Product Change Notification: P-22-023058

Modular jack connector

Change from EPS Tray to PET Tray

Packaging change from EPS Tray to PET Tray

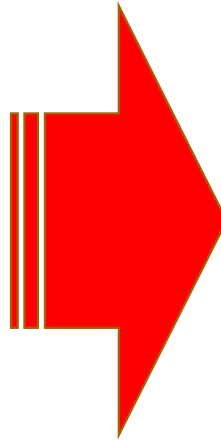
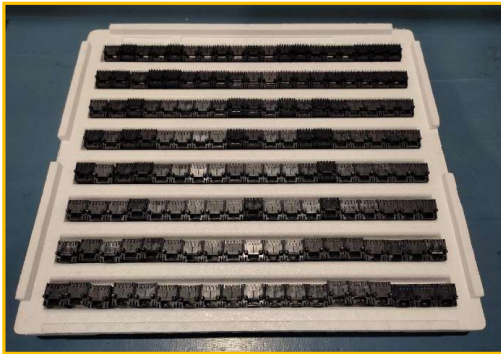
Description of change:- Change from EPS Tray to PET Tray

Reason for change :- To Improve packaging efficiency and improve and address the complaints for the contacts damage and deformation
